भारत सरकार — रेल मंत्रालय  
अनुसंधान अभिकल्प और मानक संगठन  
लखनऊ — 226011  
Government of India - Ministry of Railways  
Research, Designs & Standards Organization.  
LUCKNOW - 226011

No. EL/3.1.3.5/2(Elect)

**Modification Sheet No. RDSO/2017/EL/MS/0464, (Rev.0)**

Provision of Auxiliary interlock for monitoring of A2-B2 segment of Harmonic filter ON (8.1)/adoption (8.2) Contactor in GTO/IGBT locomotives.

Fig-1 Circuit Diagram of auxiliary contact for contact 8.1

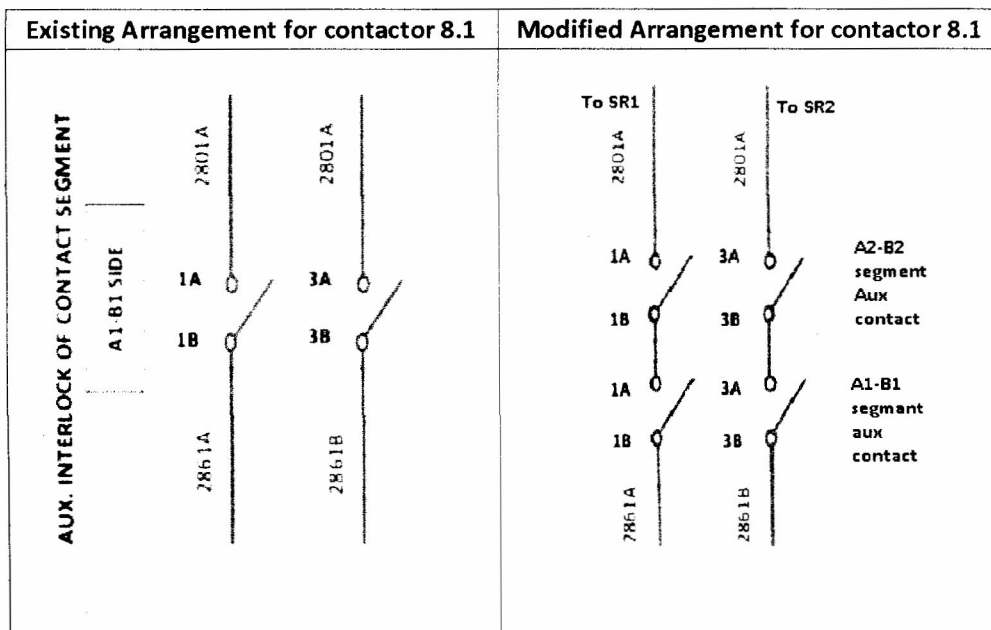
In order to prevent failure of loco and fire incidences due to breakage of the cross bar and consequent wrong feedback to the ALG controllers, modification need to be carried out by providing auxiliary interlocks in the side of segment A2-B2 and connecting them in series with auxiliary interlocks of A1-B1. Both the auxiliary contacts should be 'NO' type. In the present arrangement 1A-1B and 3A-3B contacts are in general 'NO' type. In case 'NO' type of contacts are not available at 1A-1B and 3A-3B then cams may be interchanged to accommodate the two 'NO' interlocks.

After this modification ALG1/ALG2 controllers get contactor closing feedback only after closing of both the segments.

The circuit diagram of existing and modified arrangement for contactor 8.1 & 8.2 are given below in Fig-1 and Fig-2 respectively:
